Overview: The initial production release of the FTI-TLK1 harness has an issue where in some vehicles the secondary power input to the CN1 connector will overload the associated vehicle circuit, causing a fuse to blow. This issue affects the initial release of harnesses and is already being addressed in production. A field correction procedure is detailed below in Figure 1.

FTI-TLK1 Type 1A - Vehicle Coverage & Preparation Notes

FTI-TKL1 Type 1A - Installation Notes & Wiring Diagram

Figure 1: Step by step adapter correction

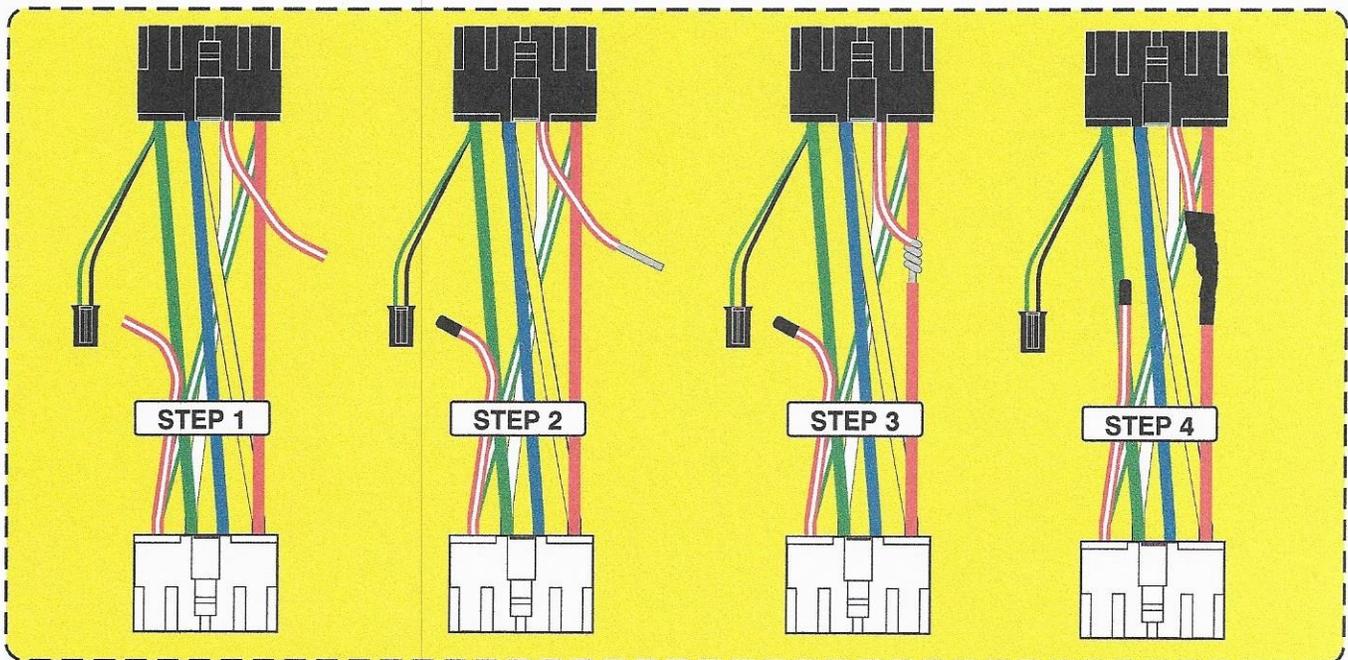
Issue: The secondary power circuit can overload some vehicle ignition switch circuits, causing a blown 5A/7.5A AM1 fuse, potentially disabling the vehicle and leaving the consumer stranded. Affected adapters are illustrated below in figure 2.

Corrective steps:
1.) Select the applicable CN1 adapter, isolate the RED/WHITE power wire, cut wire approximately 4" from the BLACK plug
2.) Insulate the wire still connected to the WHITE plug using heat shrink tubing, and strip the insulation on the other wire end
3.) Strip a portion of the insulation from the RED wire, attach the stripped RED/WHITE to the exposed RED wire, solder together
4.) Apply insulating tape to the soldered connection and secure the cut ends back to the bundle of wires created by the adapter
5.) Correction complete, you may safely proceed to finish your installation

Figure 2: Supplied CN1 Harness Adapters

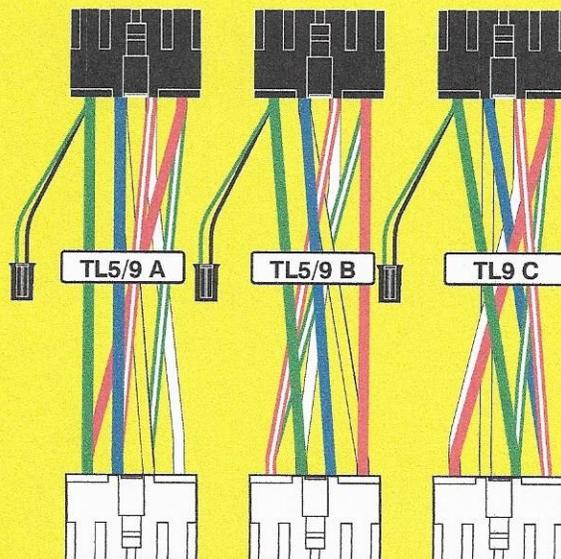
Incorrect power provisions with the potential to overload vehicle ignition supply circuit, resulting in blown AM1 fuse.

Figure 1: Step by step adapter correction

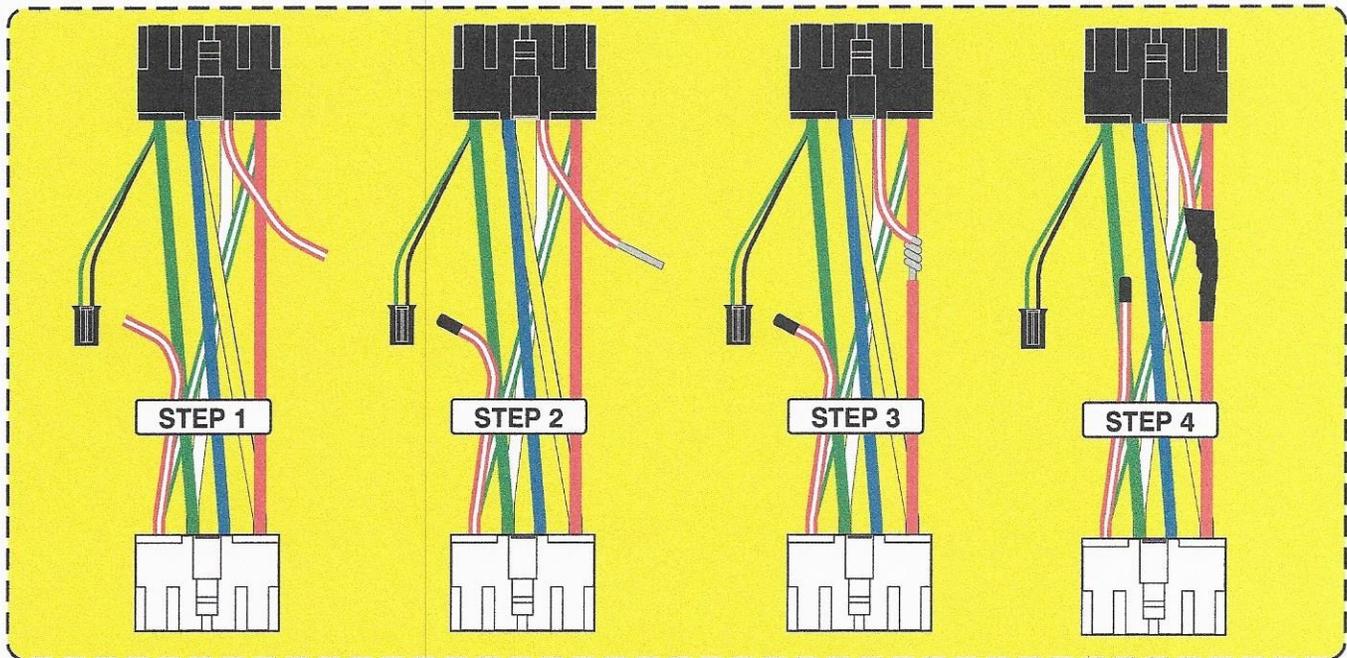
Overview: The initial production release of the FTI-TLK1 harness has an issue where in some vehicles the secondary power input to the CN1 connector will overload the associated vehicle circuit, causing a fuse to blow. This issue affects the initial release of harnesses and is already being addressed in production. A field correction procedure is detailed below in Figure 1.

Issue: The secondary power circuit can overload some vehicle ignition switch circuits, causing a blown 5A/7.5A AM1 fuse, potentially disabling the vehicle and leaving the consumer stranded. Affected adapters are illustrated below in figure 2.

Corrective steps:
1.) Select the applicable CN1 adapter, isolate the RED/WHITE power wire, cut wire approximately 4" from the BLACK plug
2.) Insulate the wire still connected to the WHITE plug using heat shrink tubing, and strip the insulation on the other wire end
3.) Strip a portion of the insulation from the RED wire, attach the stripped RED/WHITE to the exposed RED wire, solder together
4.) Apply insulating tape to the soldered connection and secure the cut ends back to the bundle of wires created by the adapter
5.) Correction complete, you may safely proceed to finish your installation

Figure 2: Supplied CN1 Harness Adapters

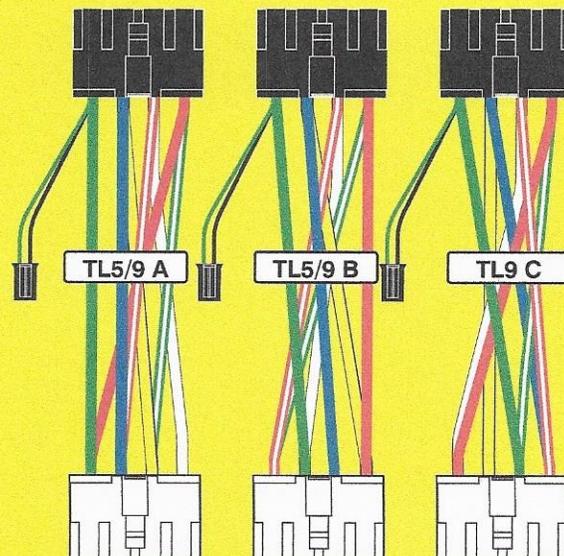
Incorrect power provisions with the potential to overload vehicle ignition supply circuit, resulting in blown AM1 fuse.
